Access Compliance Report

Public Rights-of-Way

(Pedestrian Signals)

Intersection ID: N/A	Main Street:	Cross Street: N/A	Location: N/A
ADA ID: 131784174AF3	Signal Type: Two Push Buttons-Non APS	Overall Compliance: No	Severity Score: BTN 1:N/A BTN 2: N/A No BTN: N/A
Codes/Mitigation Info/Possible Solution		Field Measurements/Component Compliance

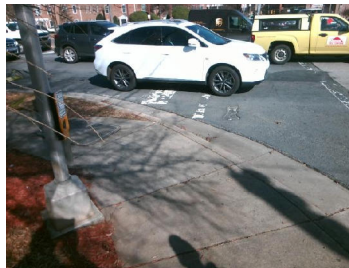
PROW/ADA: TMUTCD 4e.08, R404.2, R404.3, R406.2,

Compliance	Description	Data	Compliance	Description	Data
	Button Count	Button2	N/A	Distant to Additional Button (in)	N/A
	Additional Button Present?	No		Additional Button ID	N/A
N/A	Signal Buttons Required?	N/A	N/A	Additional Ped Posts Required	N/A
	How Many Ped Street Xings?	2		Located In An Island/Median?	No
N/A	B 1 Sign Present?	Yes	N/A	B 2 Sign Present?	Yes
Yes	B 1 Sign Purpose?	Yes	Yes	B 2 Sign Purpose?	Yes
Yes	B 1 Sign Lettering & Contrast?	Yes	Yes	B 2 Sign Lettering & Contrast?	Yes
Yes	B 1 Parallel To XWalk?	Yes	Yes	B 2 Parallel To XWalk?	Yes
Yes	B 1 PAR to Button?	Yes	Yes	B 2 PAR to Button?	Yes
Yes	B 1 PAR to XWalk?	Yes	Yes	B 2 PAR to XWalk?	Yes
Yes	B 1 Clear Floor Space?	Yes	Yes	B 2 Clear Floor Space?	Yes
N/A	B 1 FWD Approach?	Yes	N/A	B 2 FWD Approach?	Yes
N/A	B 1 FWD Approach Constrained?	No	N/A	B 2 FWD Approach Constrained?	No
No	B 1 FWD Approach Reach (in)	12.0	No	B 2 FWD Approach Reach (in)	10.0

N/A	B 1 FWD Approach Width (in)	N/A	N/A	B 2 FWD Approach Width (in)	N/A
N/A	B 1 FWD Approach Obstruction?	Yes	N/A	B 2 FWD Approach Obstruction?	Yes
N/A	B 1 FWD Approach Obstruction Dist (in)	5.0	N/A	B 2 FWD Approach ObstructionDist (in)	4.0
N/A	B 1 PARA Approach?	Yes	N/A	B 2 PARA Approach?	Yes
N/A	B 1 PARA Approach Constrained?	No	N/A	B 2 PARA Approach Constrained?	No
Yes	B 1 PARA Approach Reach (in)	8.0	Yes	B 2 PARA Approach Reach (in)	6.0
N/A	B 1 PARA Approach Width (in)	N/A	N/A	B 2 PARA Approach Width (in)	N/A
N/A	B 1 PARA Approach Obstruction?	Yes	N/A	B 2 PARA Approach Obstruction?	Yes
N/A	B 1 PARA Approach Obstruction Dist (in)	4.0	N/A	B 2 PARA Approach ObstructionDist (in)	4.0
No	B 1 Clear Floor Space Slope (%)	4.0	No	B 2 Clear Floor Space Slope (%)	3.6
Yes	B 1 Clear Floor Space XSlope (%)	1.2	No	B 2 Clear Floor Space XSlope (%)	3.9
N/A	B 1 PAR Slope (%)	0.4	N/A	B 2 PAR Slope (%)	2.8
Yes	B 1 Height (in)	39.0	Yes	B 2 Height (in)	39.0

Yes	B 1 Clear Xing Direction?	ClearlyMarked	Yes	B 2 Clear Xing Direction?	ClearlyMarked
	B 1 Crossing Direction	To SE		B 2 Crossing Direction	To NE
Yes	B 1 DistanceTo XWalk (in)	14.0	Yes	B 2 DistanceTo XWalk (in)	27.0
No	B 1 DistanceTo Curb (in)	86.0	No	B 2 DistanceTo Curb (in)	86.0
Yes	B 1 Diameter (in)	2.0	Yes	B 2 Diameter (in)	2.0

Possible Solutions: Replace Signal Push Button With APS Button on New Post. Remove & Relocate Sign.
